# CORRIGENDUM

**ETS 300 389**

**This corrigendum modifies  
the European Telecommunication Standard ETS 300 389 (1994)**  
(standards.iteh.ai)

**Integrated Services Digital Network (ISDN);  
Circuit-mode multiple-rate unrestricted 8 kHz  
structured bearer service category  
Service description**

Figure A.2: Inter-frame TSSI

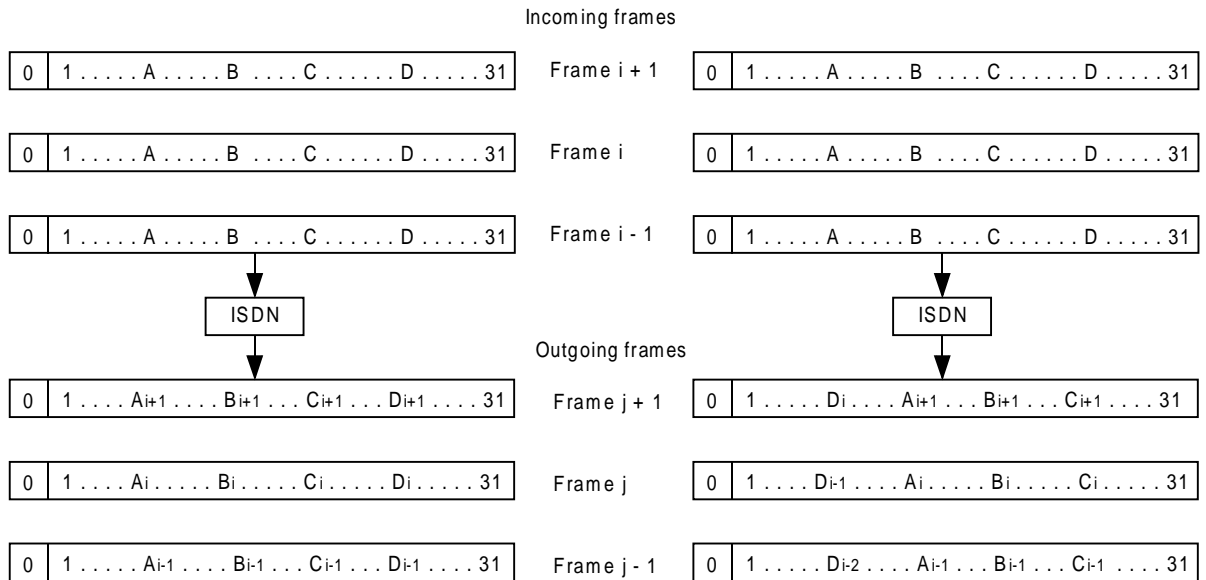
Change to clause A.2, page 17, figure A.2.

Replace figure A.2 with the following figure A.2.

Figure A.3: Intra-frame TSSI

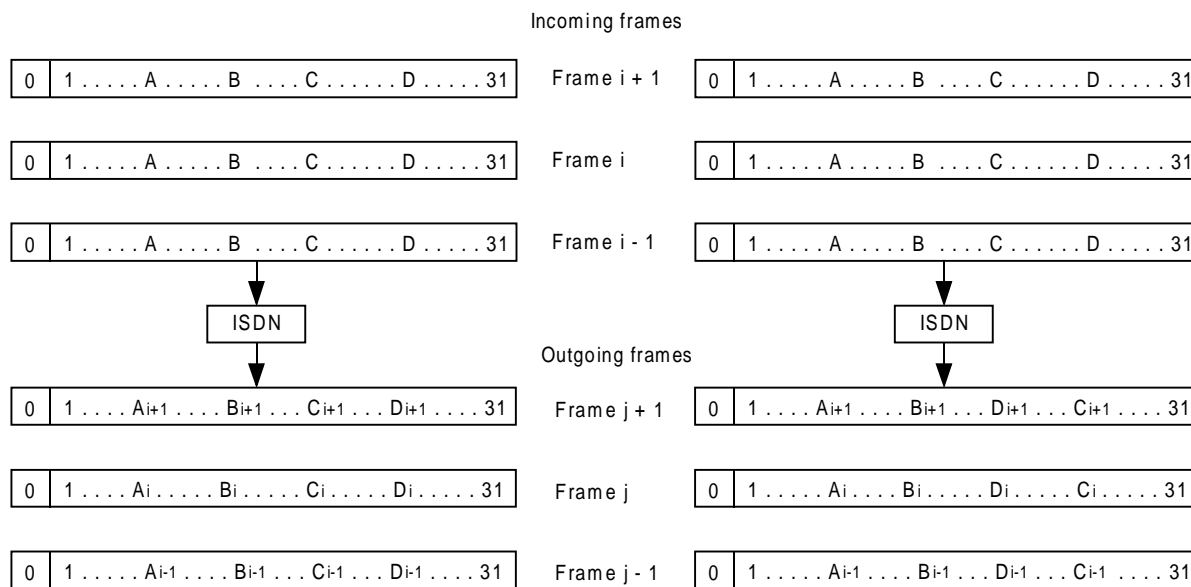
Change to clause A.3, page 18, figure A.3.

Replace figure A.3 with the following figure A.3.
